CITY OF SACRAMENTO
1231 I Street, Sacramento, CA 95814

Permit No: 0103761
Insp Area: 4

Nature of Work: NEW 13 X 15 FT PATIO COVER IN REAR

**CITY OF SACRAMENTO DEVELOPMENT SERVICES DIVISION
PLANNING AND ZONING INFORMATION REQUEST**

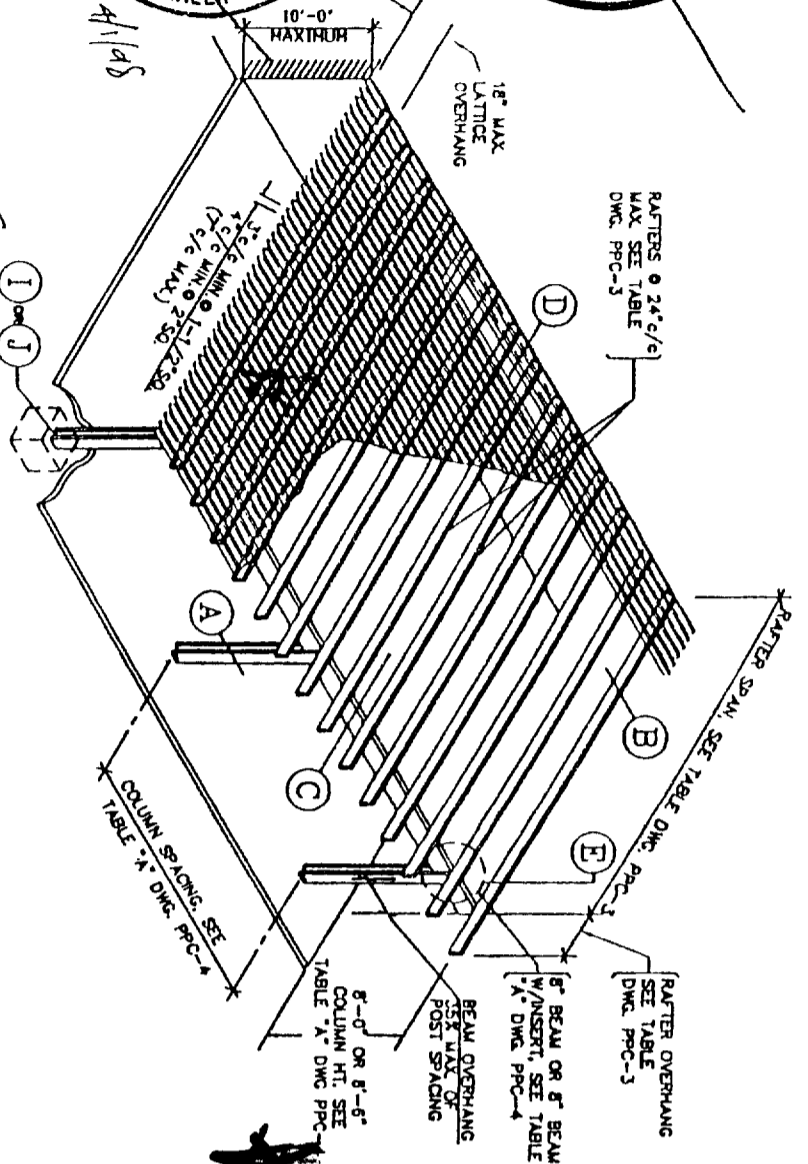
Comments: succets setback requirements, but exceeds lot coverage by 250 s.f.; 40% of 7642 s.f lot area = 3057 s.f. minus house (footprint) & garage leaves 200 s.f. + allowance of 100 s.f. toward accessory struct. = 300 s.f.

*total allowed for patio cover
Phil Reed
3/20/01*

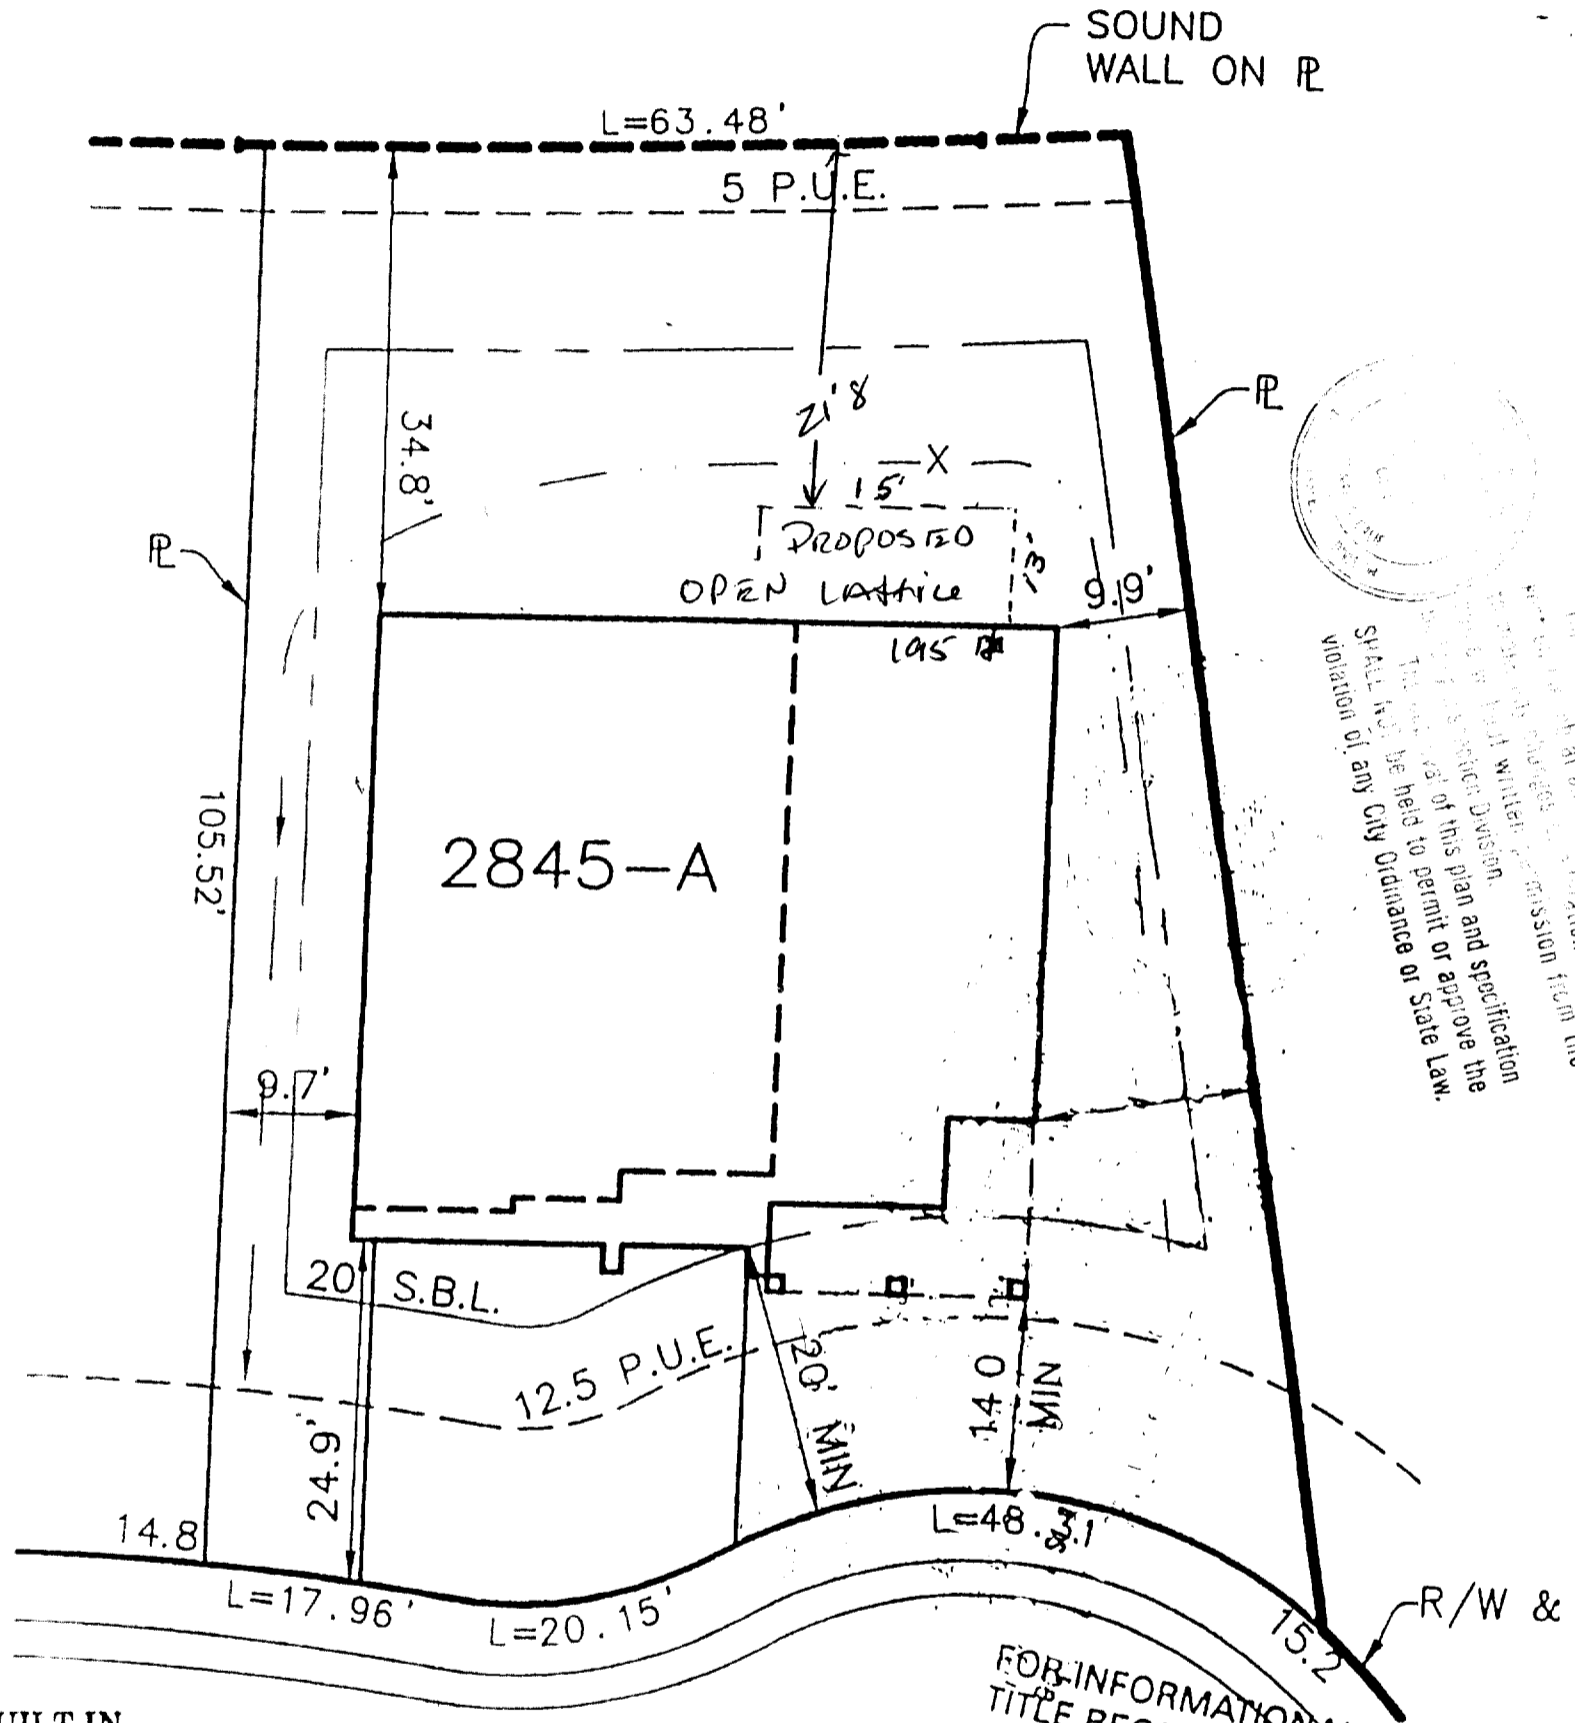
See pink slip

for planning approval
